May 12, 2011

**Reference: Request to Revise the Monitor Well Network**  
City of Durham Closed Municipal Solid Waste Landfill (Permit #32-01)  
Durham, North Carolina  
S&ME Project No. 1054-07-469

| GROUNDWATER POTENTIOMETRIC MAP |              |

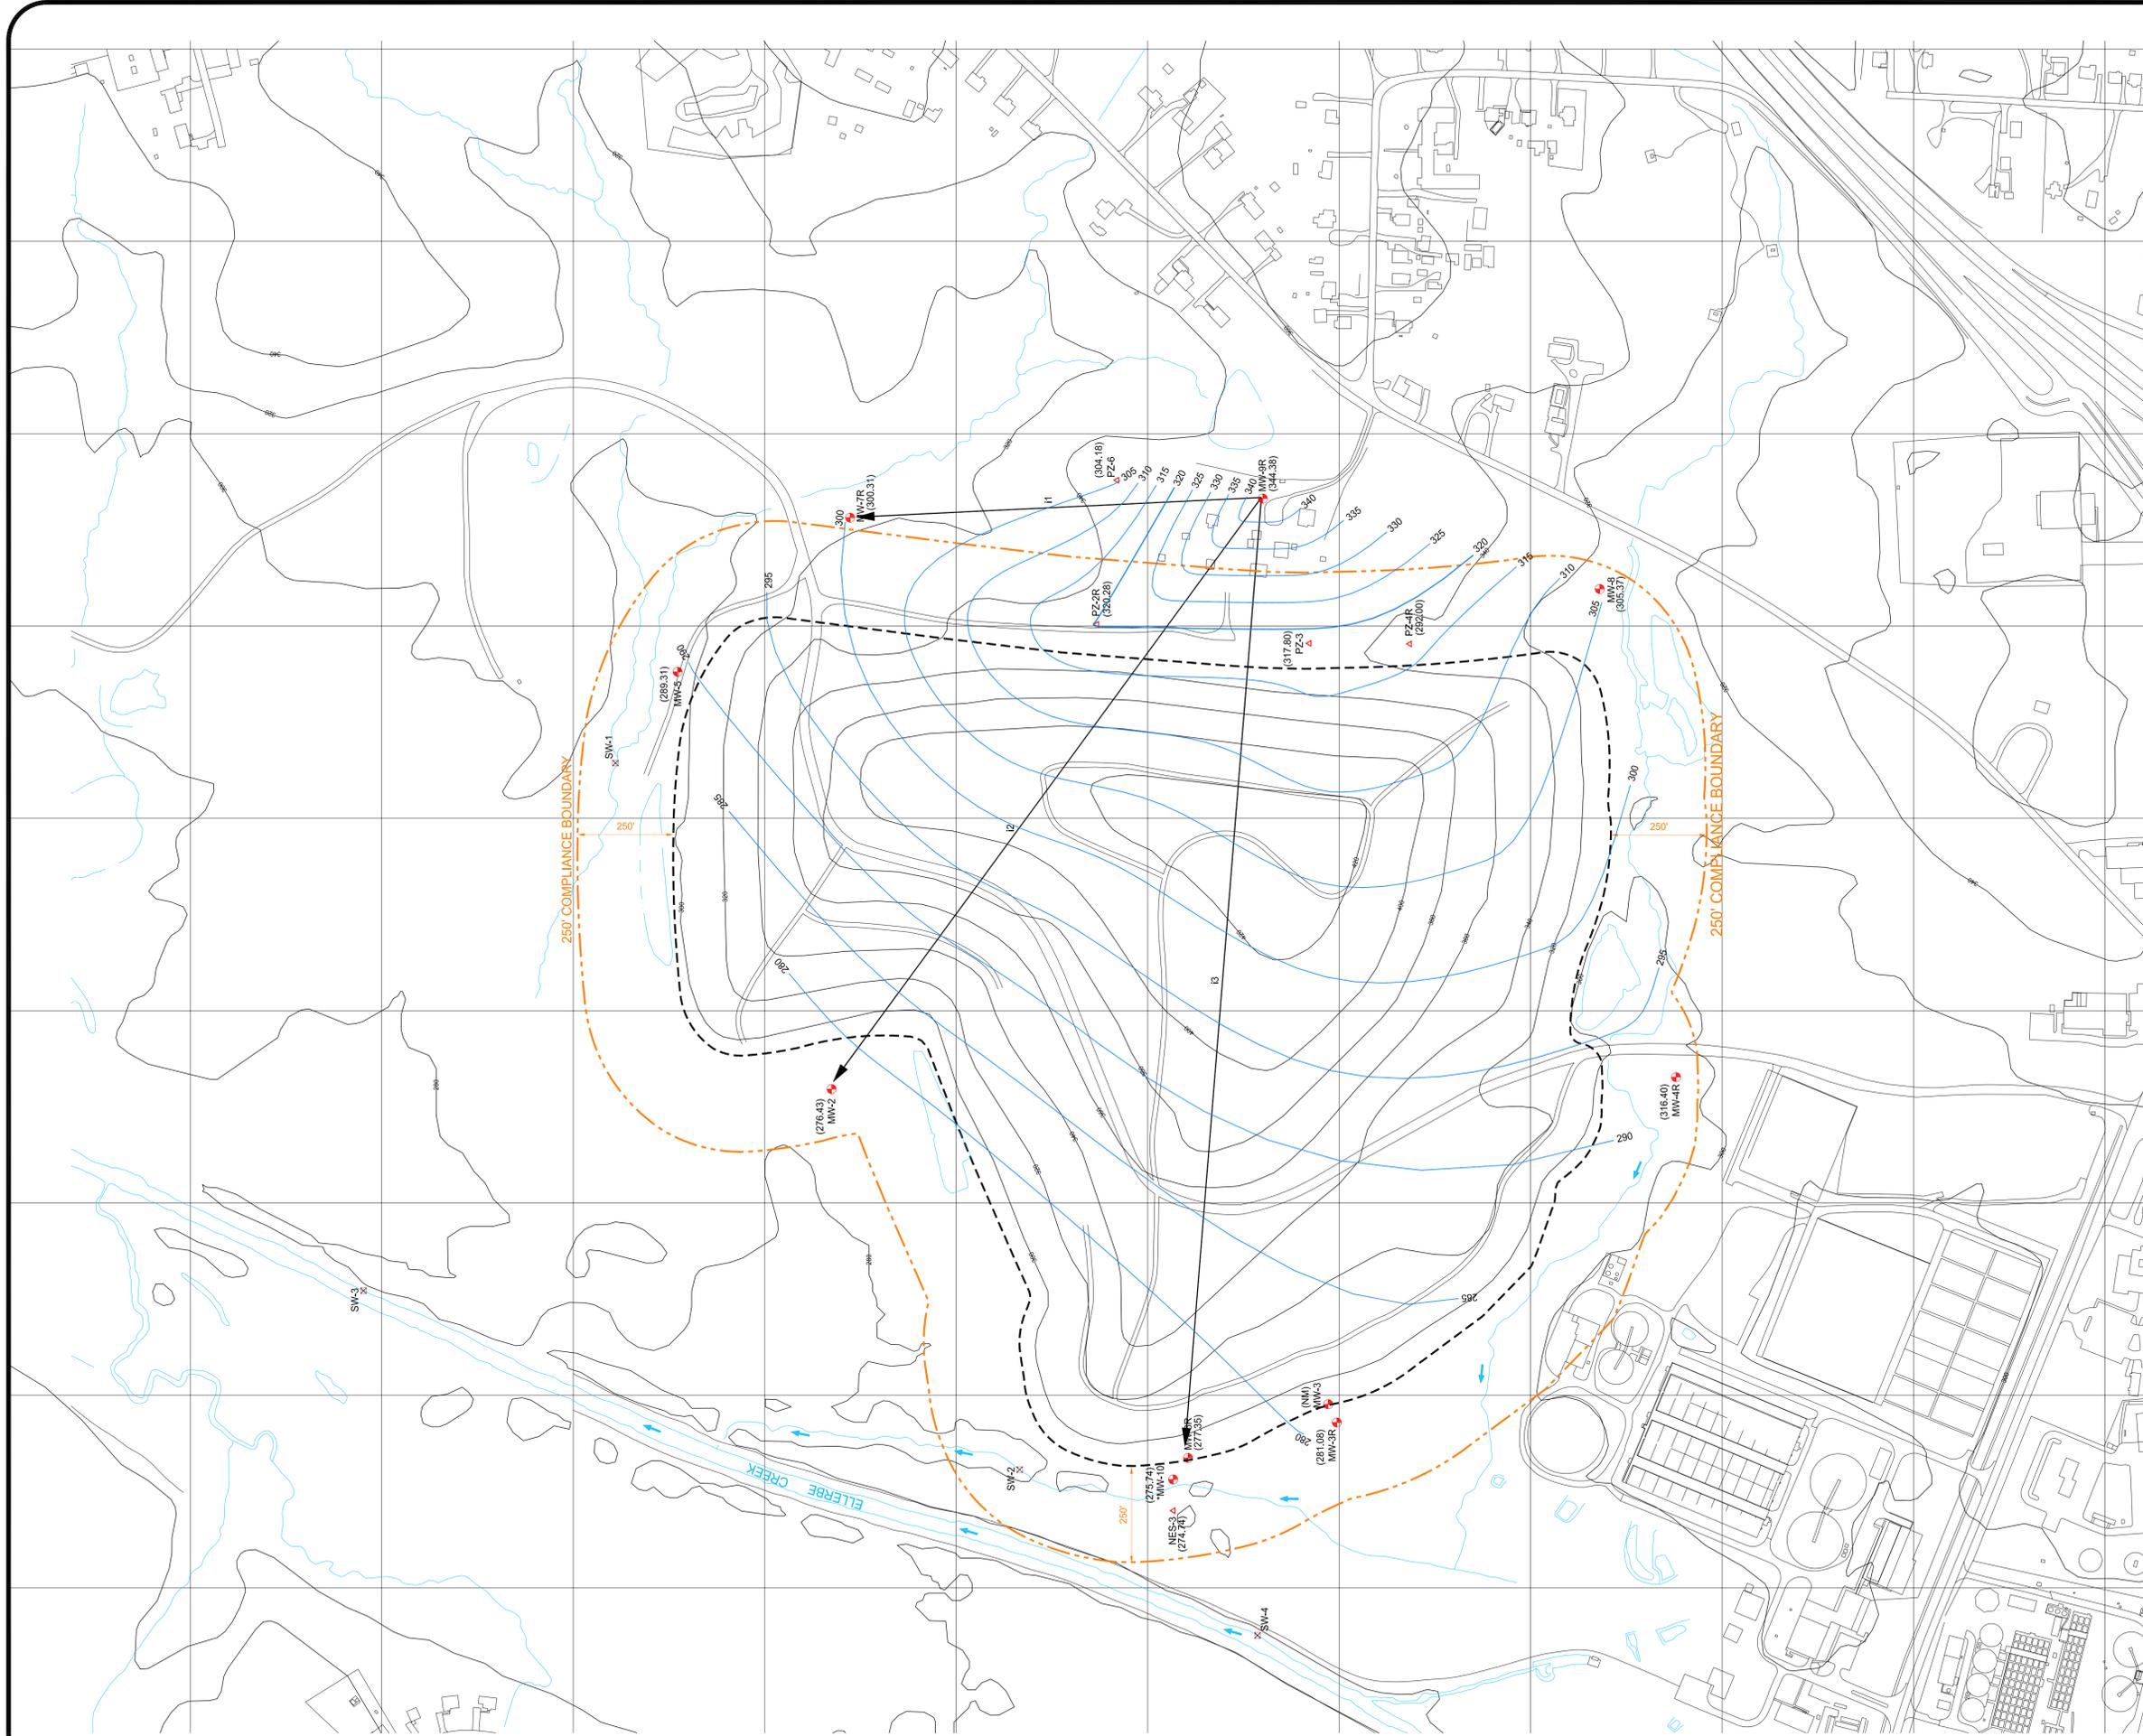
Sample locations are depicted on the attached Groundwater Potentiometric Map from the November 2010 sampling report (**Figure 3**).

In accordance with the conclusion presented in the November 2010 report, S&ME request discontinuing sampling of monitor wells MW-4R, MW-7R and MW-8. Monitor wells MW-7R and MW-8 are located up-gradient and MW-4R is located cross-gradient of the landfill.
